SP2026-005: Site Plan for 5013 Coffee

## PLANNING AND ZONING COMMISSION CASE MEMO

**CASE NUMBER:** SP2026-005; *Site Plan for a Restaurant with Less Than 2,000 SF with Drive-Through or Drive-In (5013 Coffee)*

**FRONT ELEVATION**

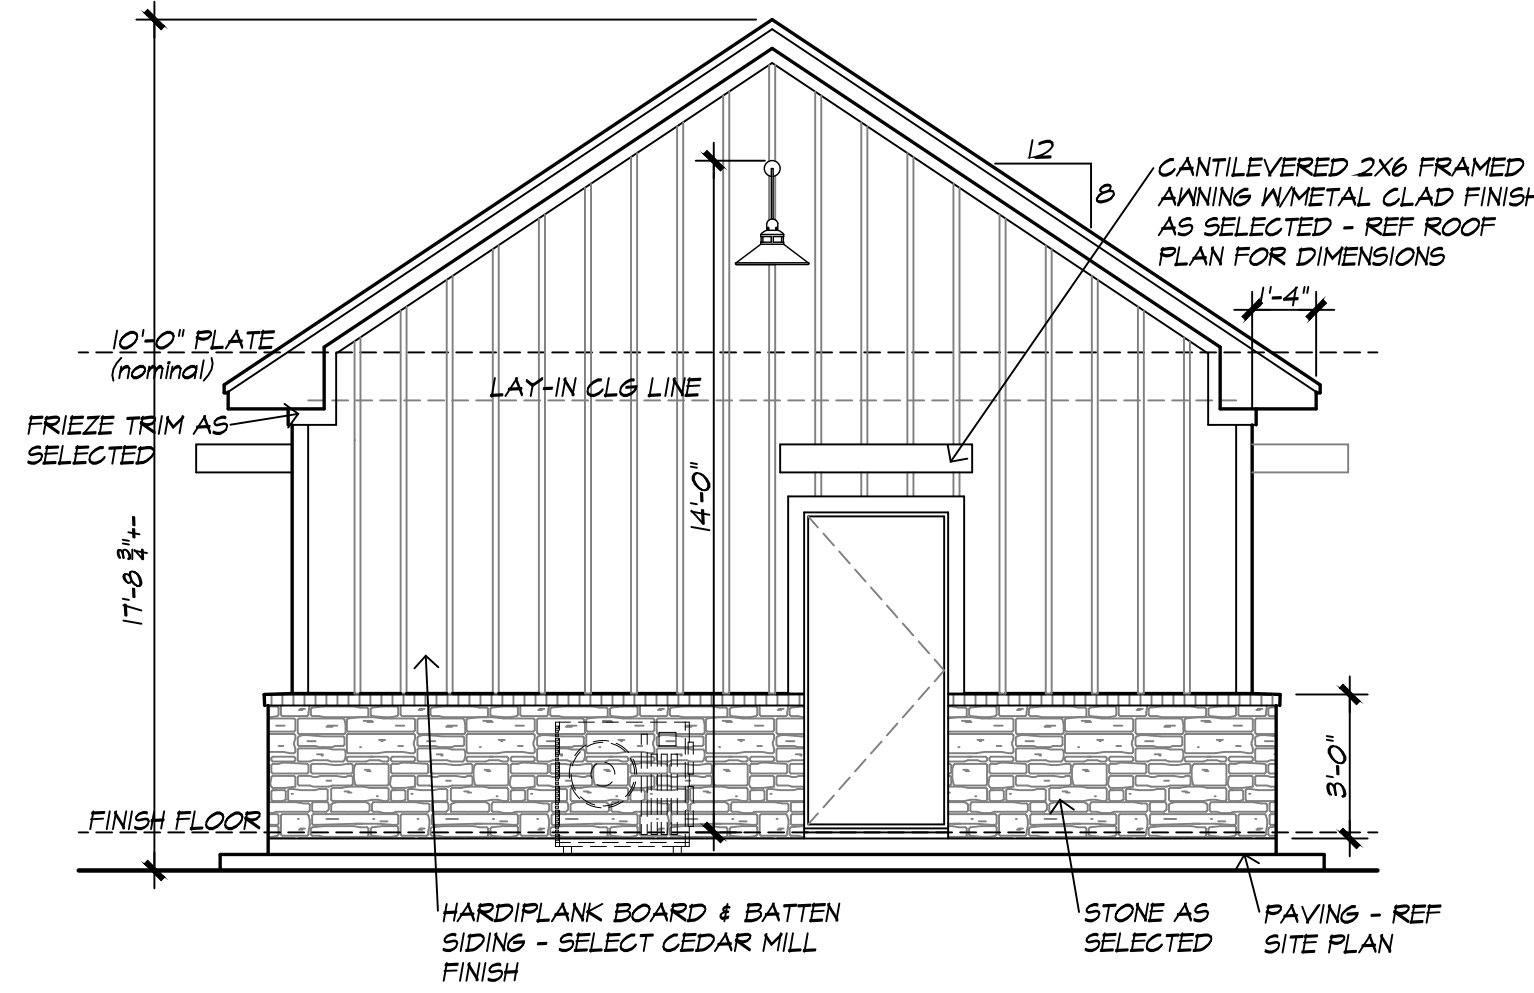
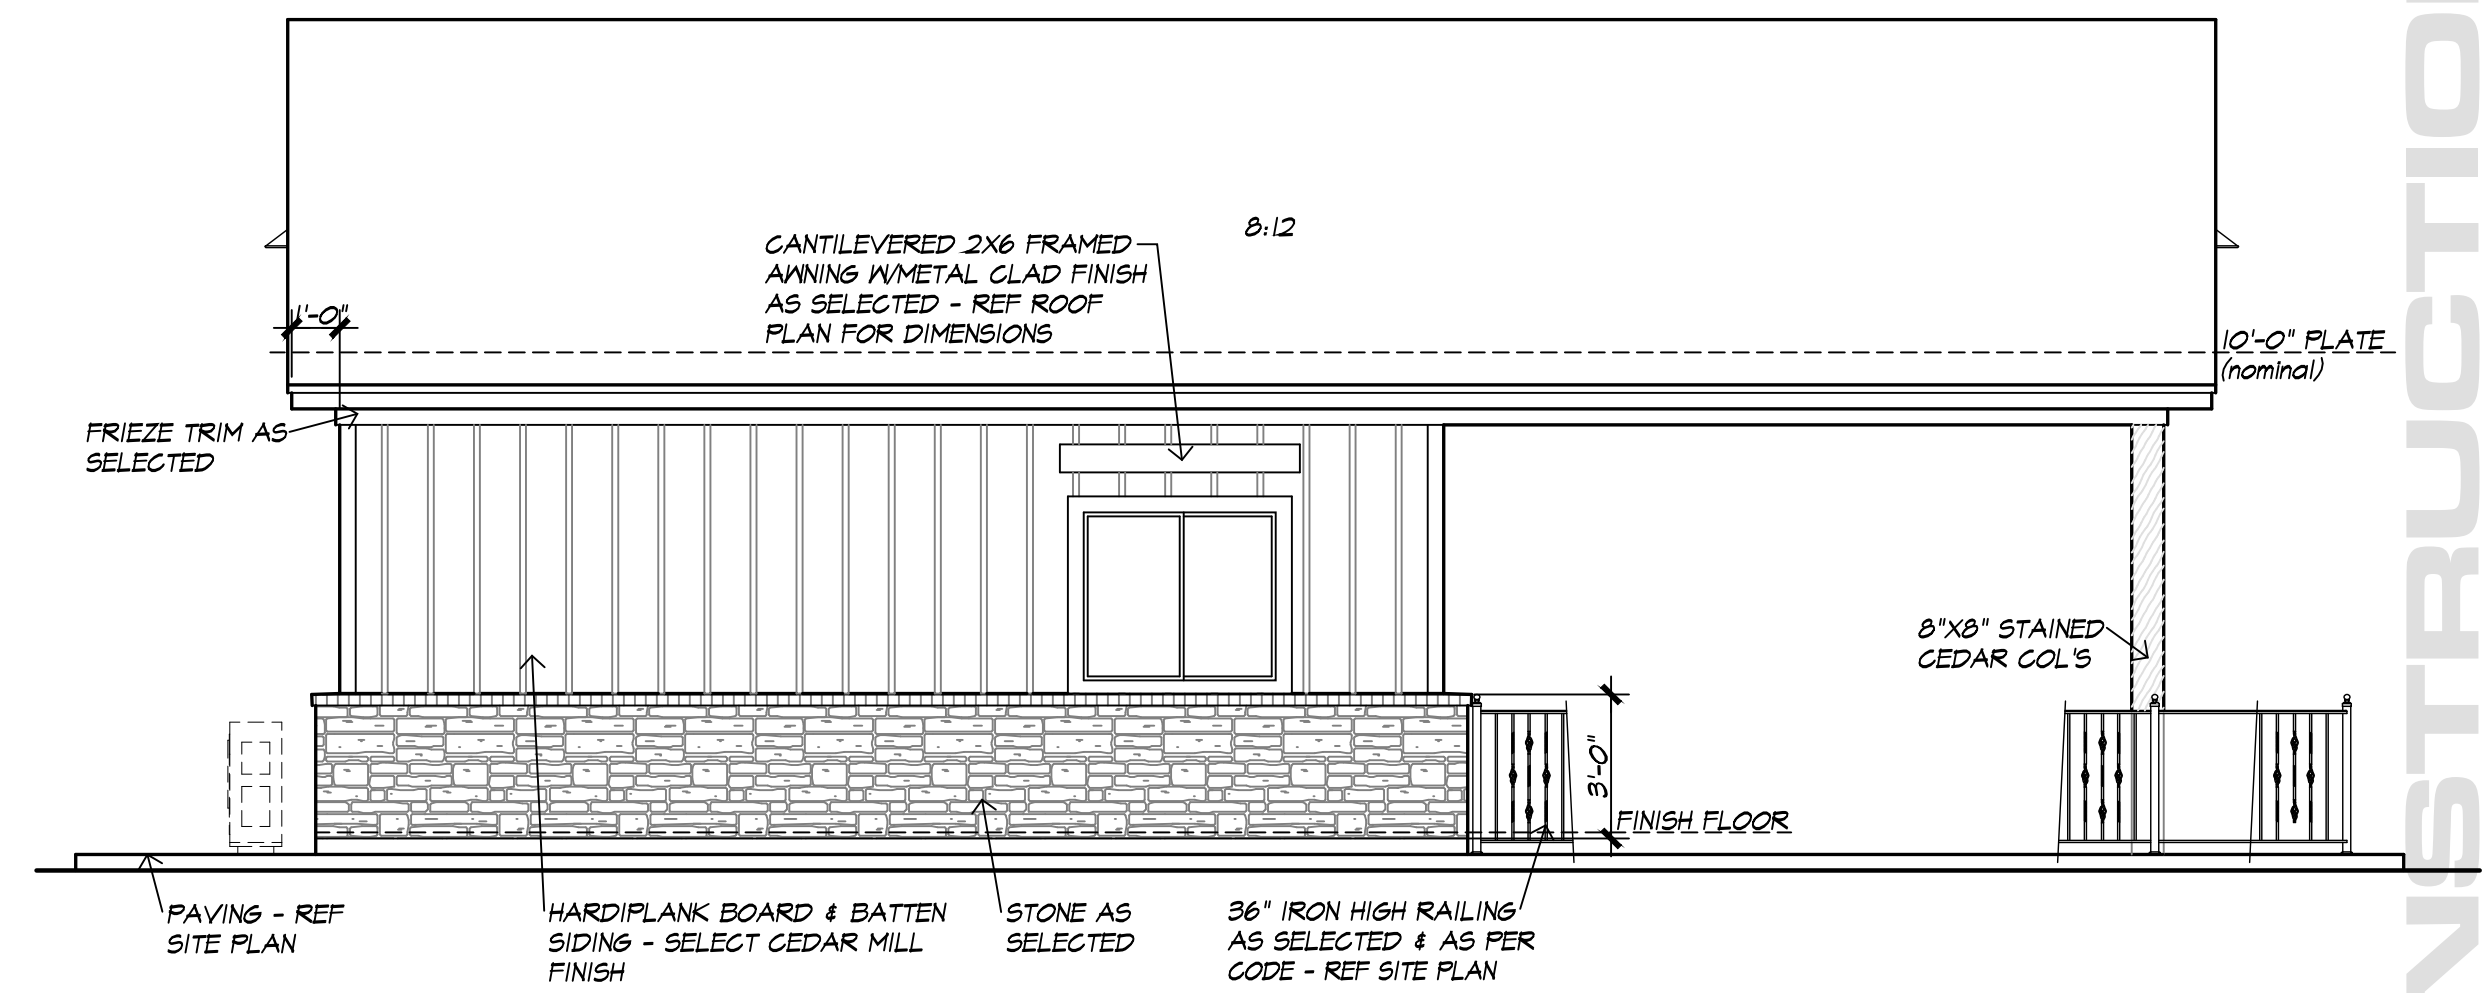
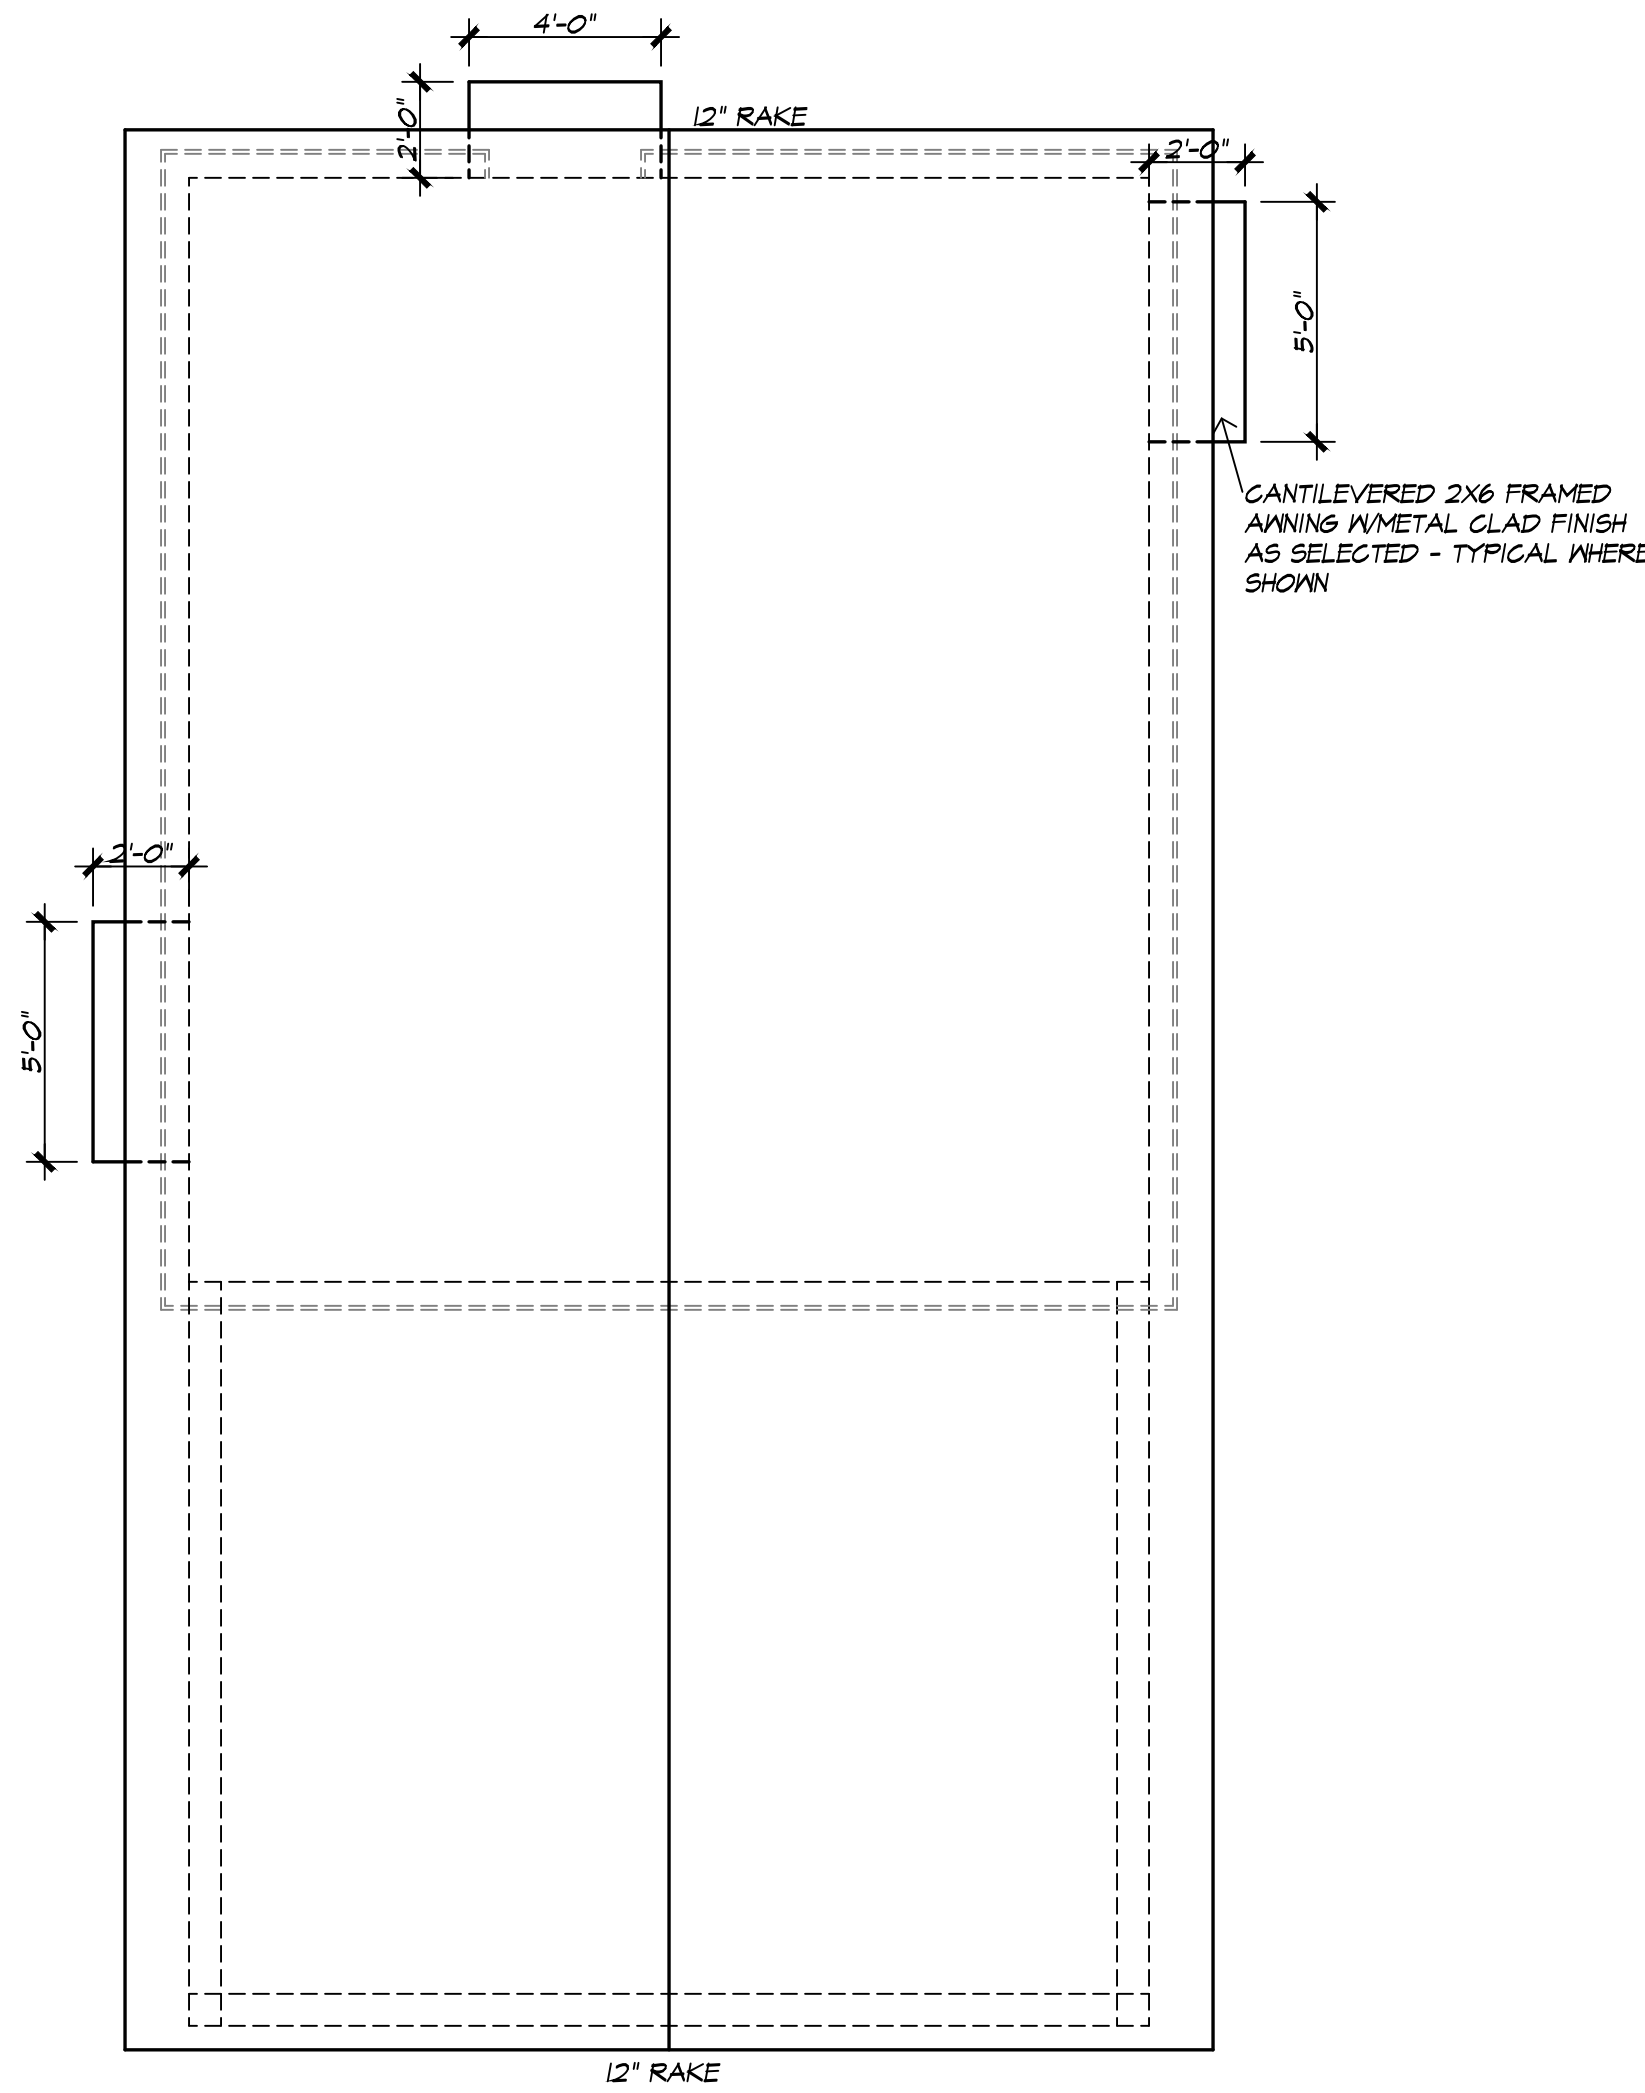
- (1) Articulation. According to Subsection 04.01, *General Commercial District Standards*, of Article 05, *District Development Standards*, of the Unified Development Code (UDC), each building façade within a Commercial (C) District must meet the minimum primary and secondary articulation standards. In this case, the proposed buildings do not meet the articulation standards; however, this is not atypical for buildings of this size. This will require an exception from the Planning and Zoning Commission.

- (2) Cementitious Materials. According to Subsection 06.02, *General Overlay District Standards*, of Article 05, *District Development Standards*, of the Unified Development Code (UDC), the use of cementitious materials shall be limited to 50.00% of the building's exterior façade. In this case, the building elevations exceed this requirement by the following: 24.64% on the west elevation, 27.88% on the east elevation, and 11.13% on the north and south elevations. This will require a variance from the Planning and Zoning Commission.
